CONSTRUCTION PLANS

4TH STREET RECONSTRUCTION PART IIA

MAP-2351(901)

PROJECT 3527.91

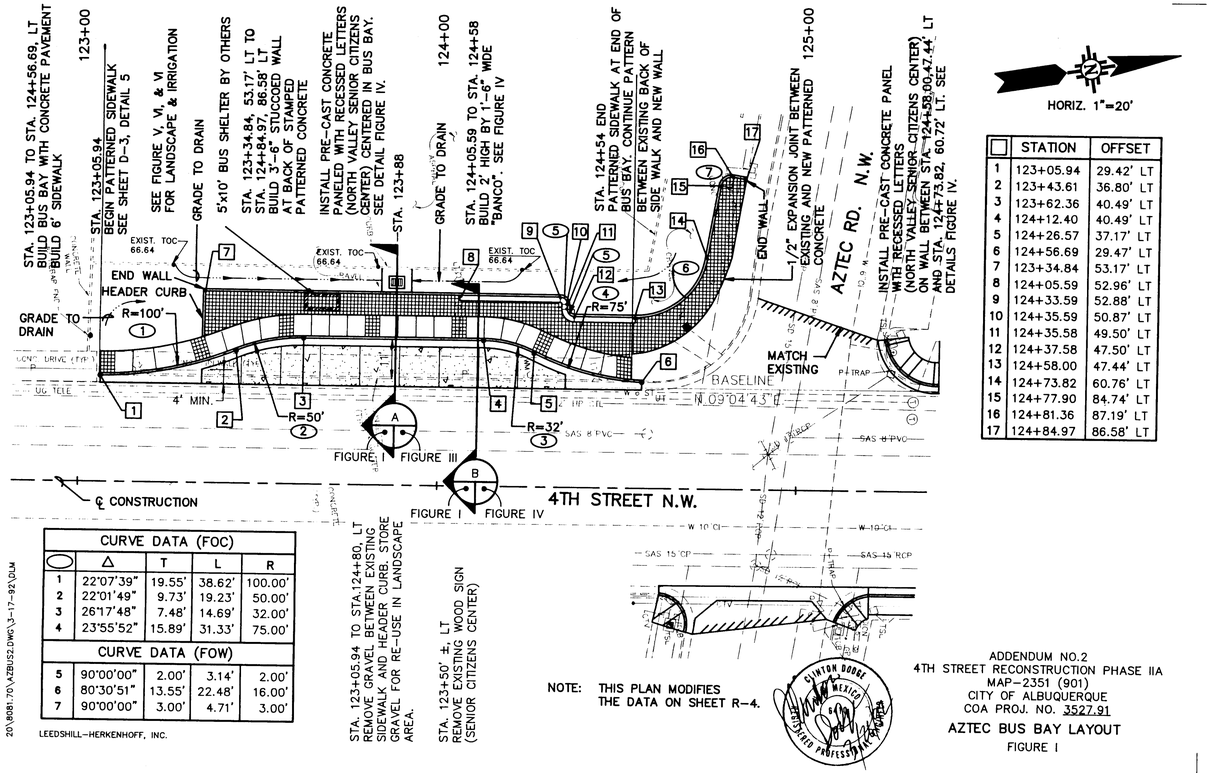
NOTE: THIS PLAN MODIFIES THE DATA ON SHEET R-4.

NOTE: THIS DETAIL MODIFIES DETAIL 7 ON SHEET D-3

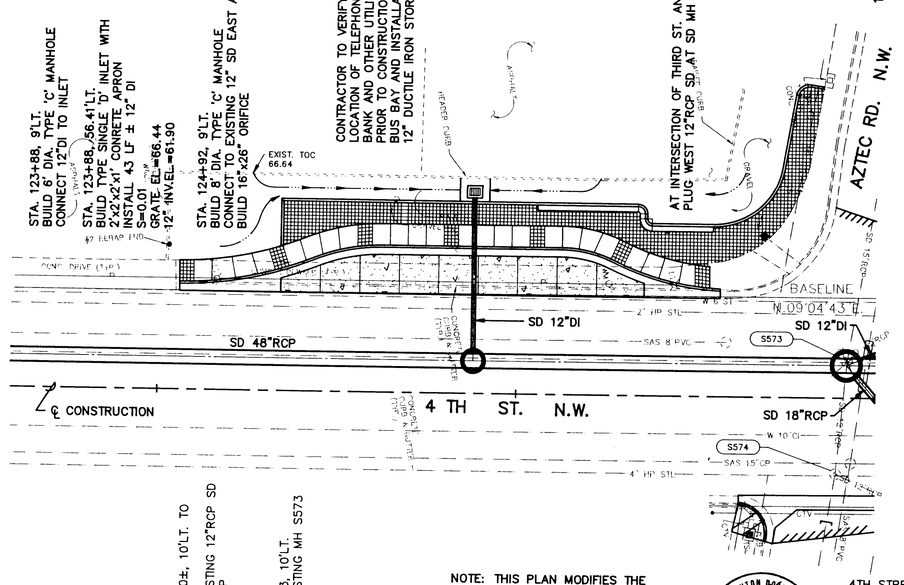
STA. 124+90±, 10'LT. TO 35'RT.
REMOVE EXISTING 12"RCP SD
PLUG 12"RCP

STA. 124+93, 10'LT.
REMOVE EXISTING MH S573

NOTE: THIS PLAN MODIFIES THE DATA ON SHEET SD-4

ADDENDUM NO. 2
4TH STREET RECONSTRUCTION PHASE II
MAP-2351(901)
CITY OF ALBUQUERQUE
COA PROJ. NO. 3527.91
RELOCATION OF CONTROLER AND METER PEDESTAL AT SW CORNER OF 4TH/CANDELARIA
FIGURE XI

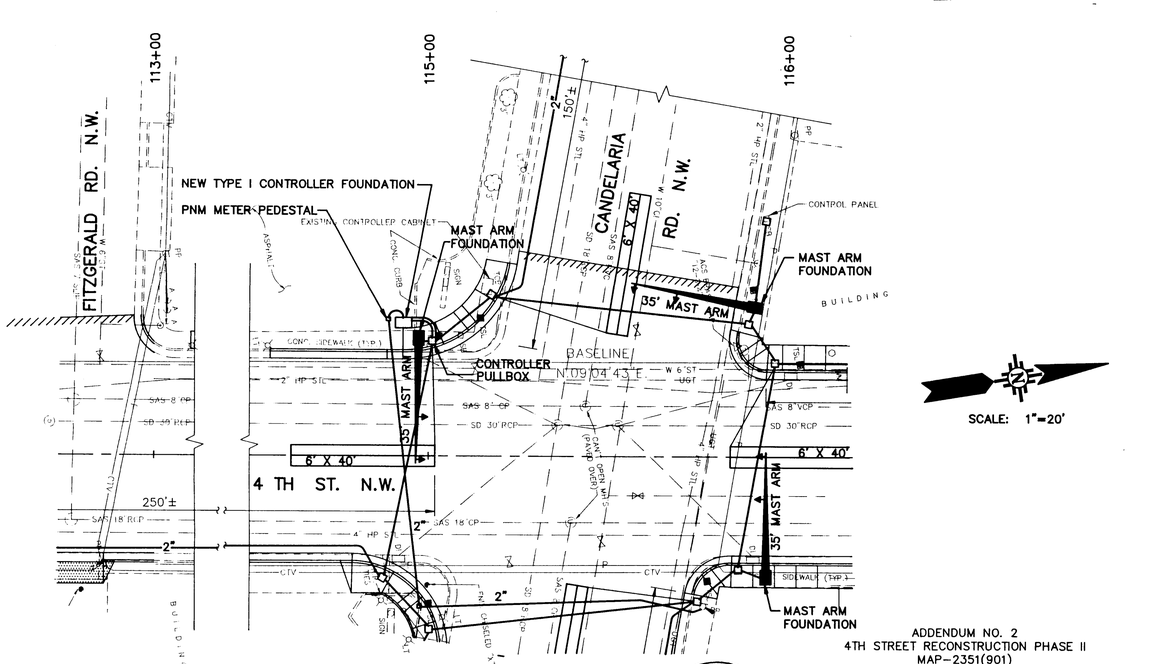
1. Modify the controller foundation and PNM meter pedestal locations in the Southwest corner as per Figure XI.

ADDENDUM NO. 2
4TH STREET RECONSTRUCTION
MAP-2351(901)
CITY OF ALBUQUERQUE
COA PROJ. NO. 3527.91
U-1 WATERLINE MODIFICATIONS
FIGURE XII

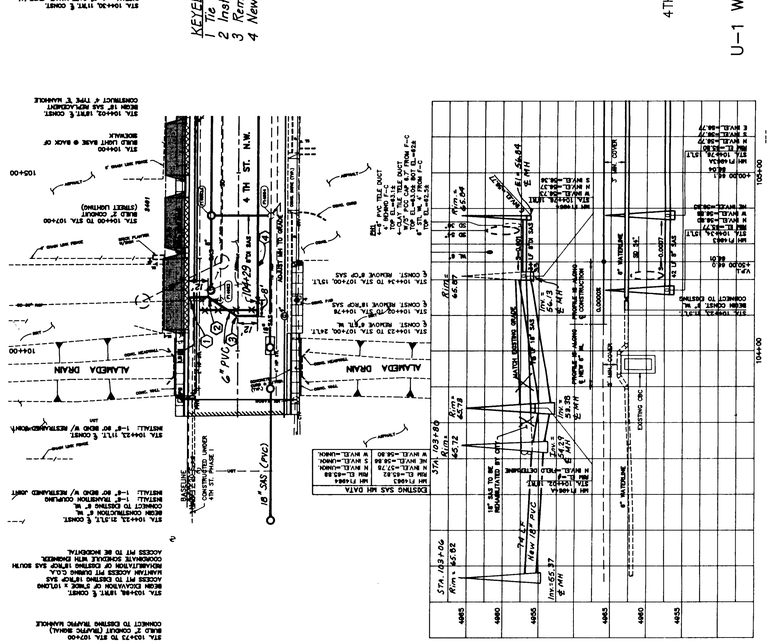
KEYED NOTES:
1 Tie to existing 6" PVC with 6"-90° bend
2 Install 1-6"-45° bend
3 Remove top cap & installed 1-6"-45° bend
4 New 6" PVC water line

FOURTH STREET PART IIA
ADDENDUM NO. 2
TEST ROADWAY SECTION SHEET D-3
FIGURE XIII

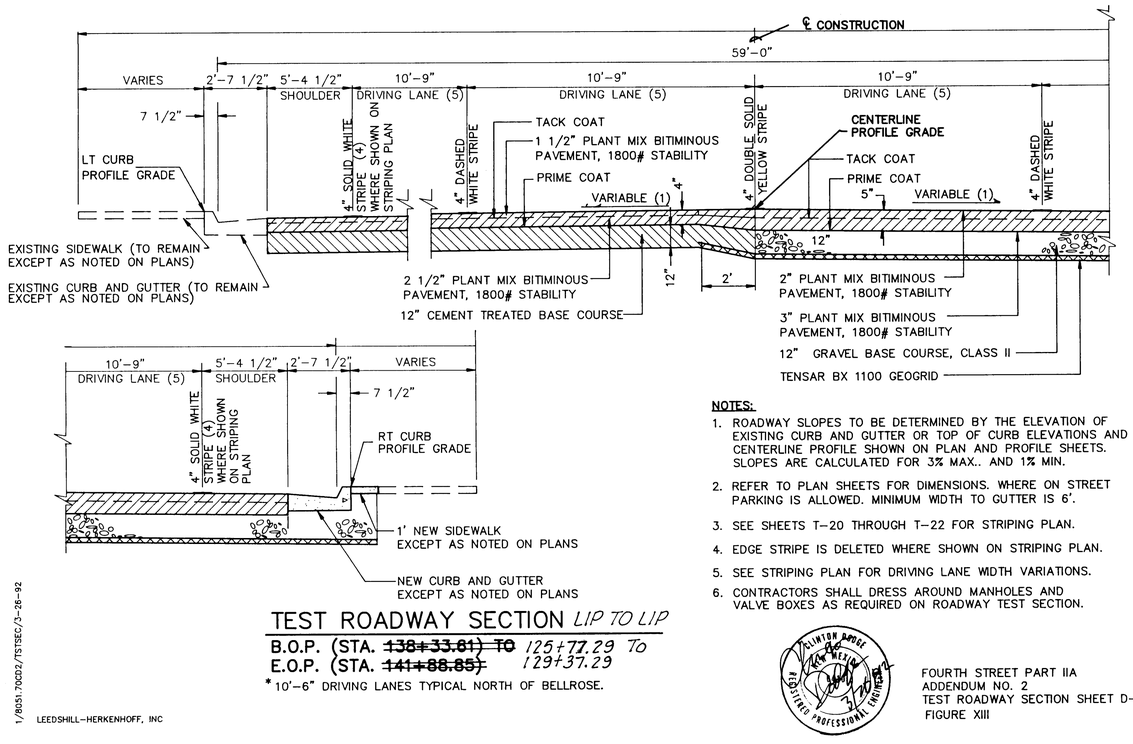
B.O.P. (STA. ~~138+33.81) TO~~ *125+77.29 To*
E.O.P. (STA. ~~141+88.85)~~ *129+37.29*

1. ROADWAY SLOPES TO BE DETERMINED BY THE ELEVATION OF EXISTING CURB AND GUTTER OR TOP OF CURB ELEVATIONS AND CENTERLINE PROFILE SHOWN ON PLAN AND PROFILE SHEETS. SLOPES ARE CALCULATED FOR 3% MAX.. AND 1% MIN.
2. REFER TO PLAN SHEETS FOR DIMENSIONS. WHERE ON STREET PARKING IS ALLOWED. MINIMUM WIDTH TO GUTTER IS 6'.
3. SEE SHEETS T-20 THROUGH T-22 FOR STRIPING PLAN.
4. EDGE STRIPE IS DELETED WHERE SHOWN ON STRIPING PLAN.
5. SEE STRIPING PLAN FOR DRIVING LANE WIDTH VARIATIONS.
6. CONTRACTORS SHALL DRESS AROUND MANHOLES AND VALVE BOXES AS REQUIRED ON ROADWAY TEST SECTION.

FOURTH STREET PART IIA
ADDENDUM NO. 2
DETAIL 1R SHEET D-1

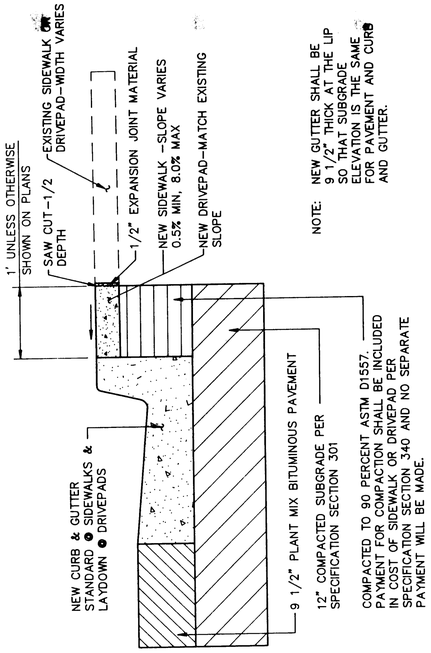
NOTE: NEW GUTTER SHALL BE 9 1/2" THICK AT THE LIP SO THAT SUBGRADE ELEVATION IS THE SAME FOR PAVEMENT AND CURB AND GUTTER.

COMPACTED TO 90 PERCENT ASTM D1557. PAYMENT FOR COMPACTION SHALL BE INCLUDED IN COST OF SIDEWALK OR DRIVEPAD PER SPECIFICATION SECTION 340 AND NO SEPARATE PAYMENT WILL BE MADE.
